SECTION 00 91 10

ADDENDUM NUMBER 2

- 1.01 DATE: September 29,2023**
- 1.02 PROJECT: ERNEST KNIGHT LLC FIRE ALARM SYSTEM**
- 1.03 PROJECT NUMBER: 26236.0 DCM/BC NO. 2023632**
- 1.04 OWNER: ALABAMA A&M UNIVERSITY**
- 1.05 ARCHITECT: HYDE ENGINEERING, INC.**

DATE:	09/29/2023
JOB NUMBER:	26236.0
DRAWN BY:	BR
CHECKED BY:	MBR
DRAWING TITLE:	LEGEND, NOTES, DETAILS AND RISER
DRAWING NO.:	E0.1

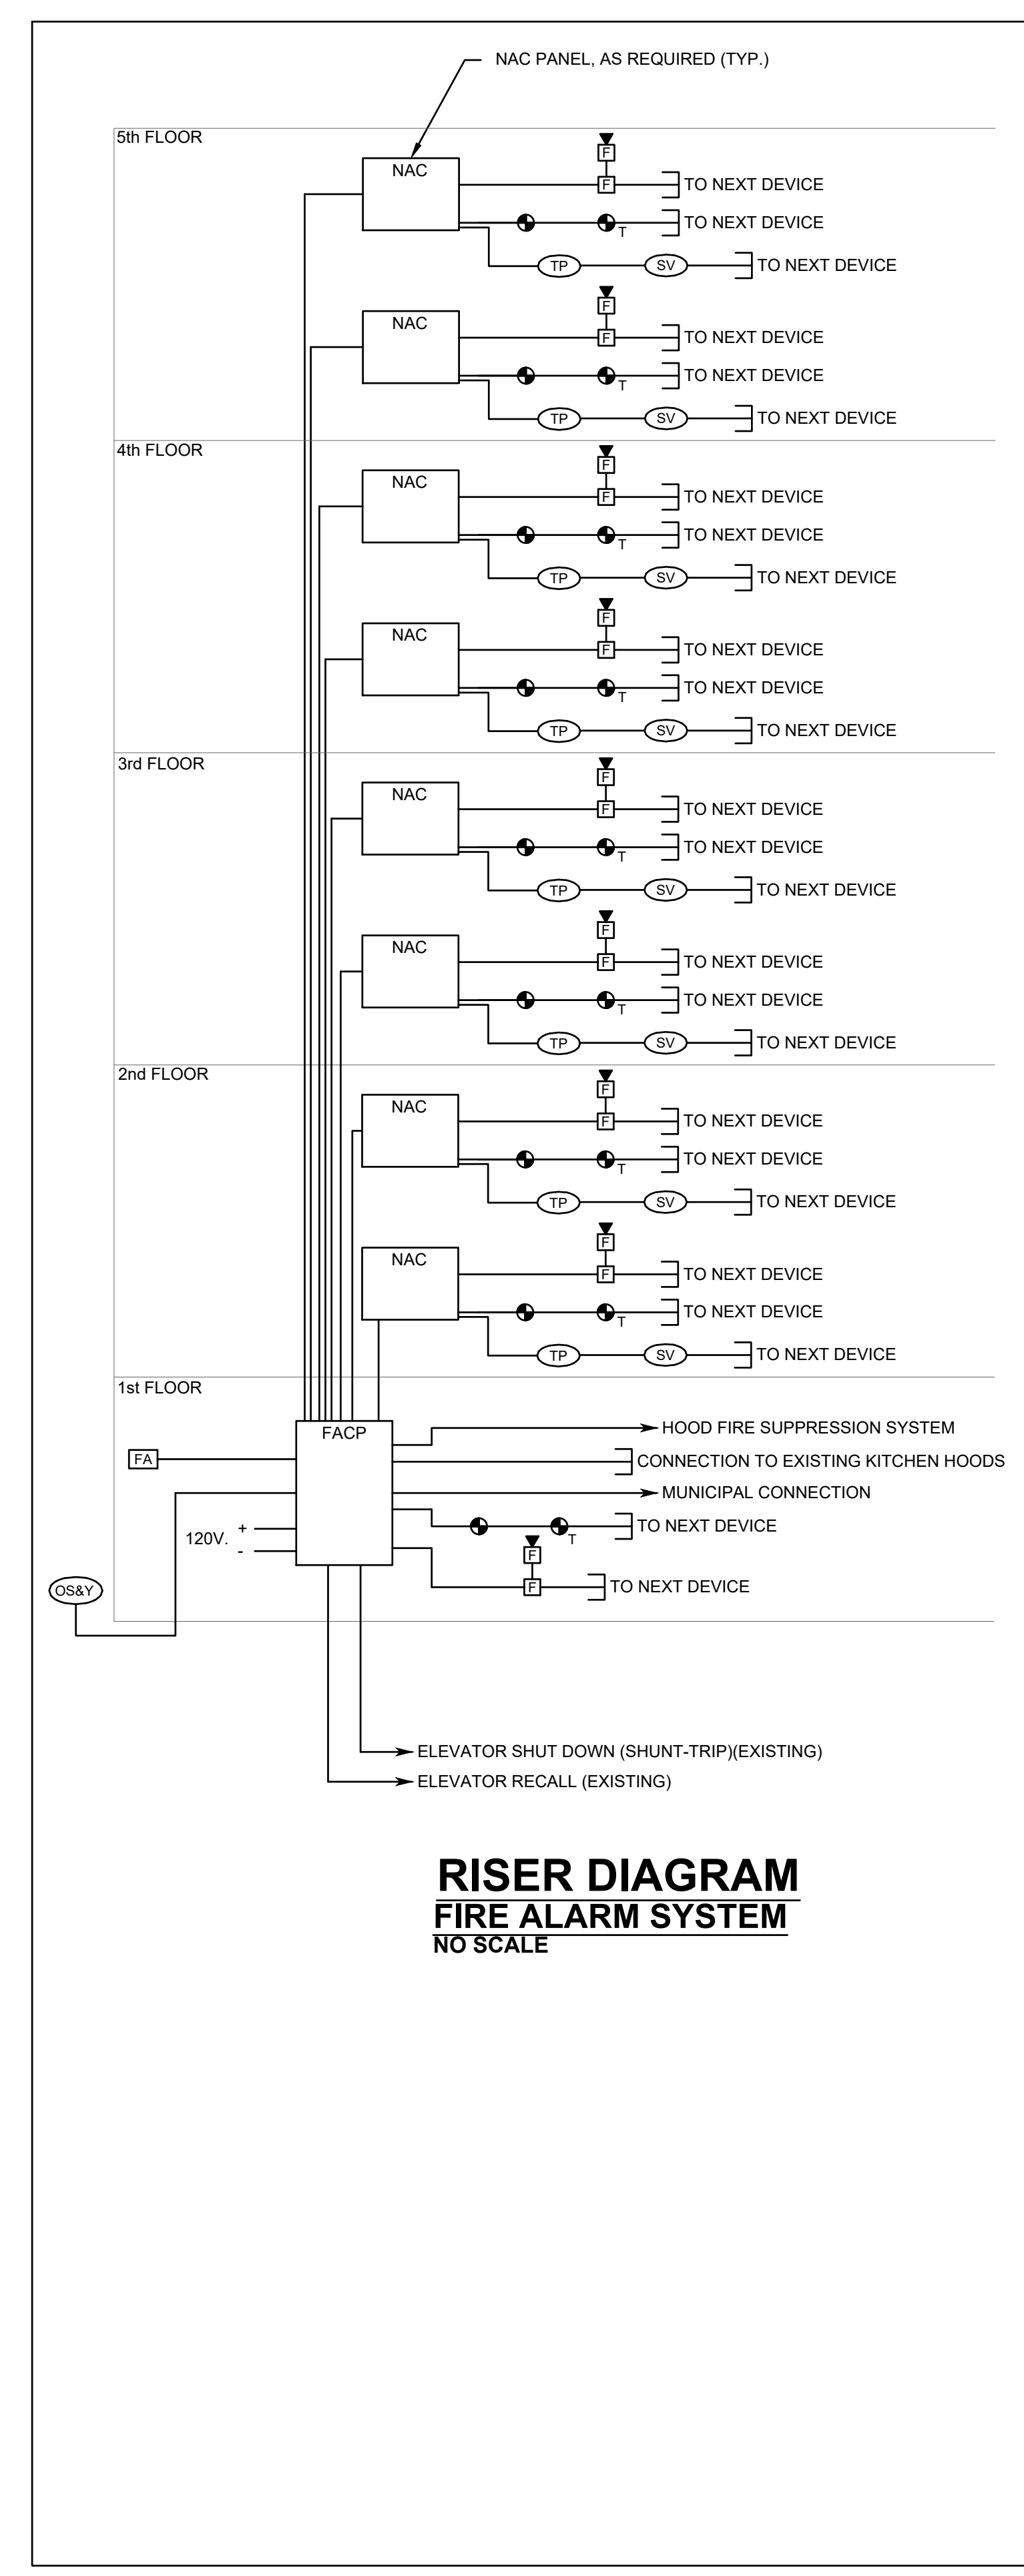
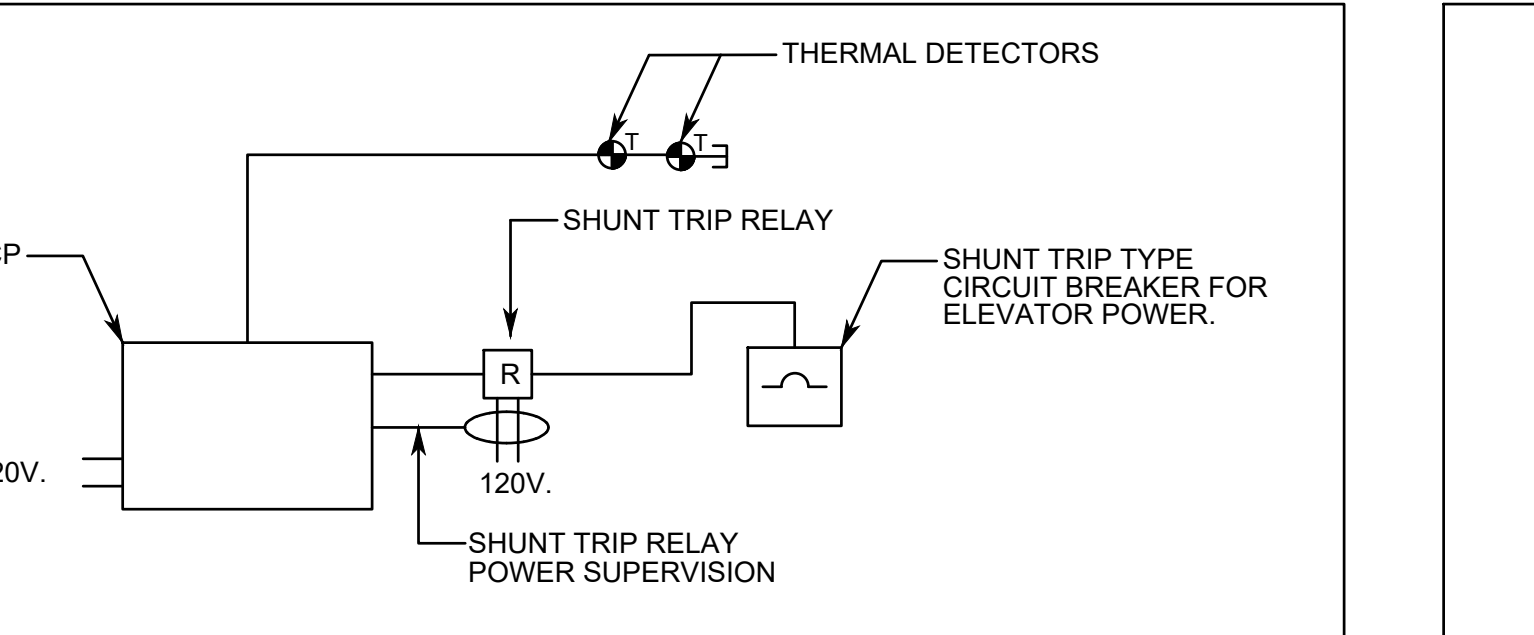
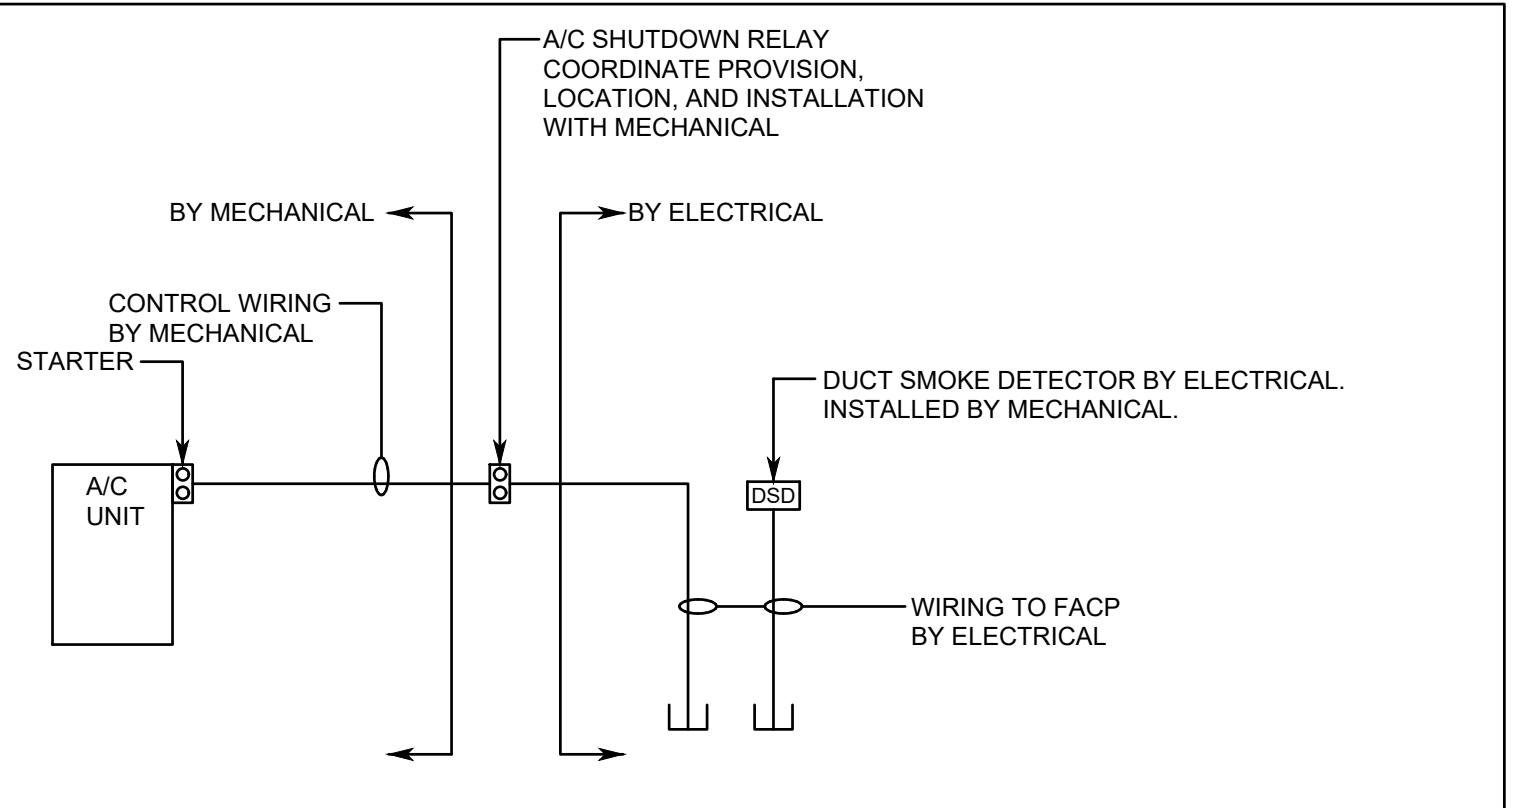
- 4.01 SHEET E0.1 – LEGEND, NOTES, DETAILS, AND RISER**
 - A. Notes J and K were added under the special construction notes.
- 4.02 SHEET E2.4 – FIRST FLOOR PLAN – AREA D – FIRE ALARM**
 - A. Three carbon monoxide detectors were added along with a note 3 typical.
 - B. Note 3 was added to the plan.
- 4.03 SHEET E4.1 – THIRD, FOURTH, AND FIFTH FLOOR PLAN – AREA A – FIRE ALARM**
 - A. Note 6 was added to the plan.
- 4.04 SHEET E4.2 – THIRD, FOURTH, AND FIFTH FLOOR PLAN – AREA B – FIRE ALARM**
 - A. Note 6 was added to the plan.
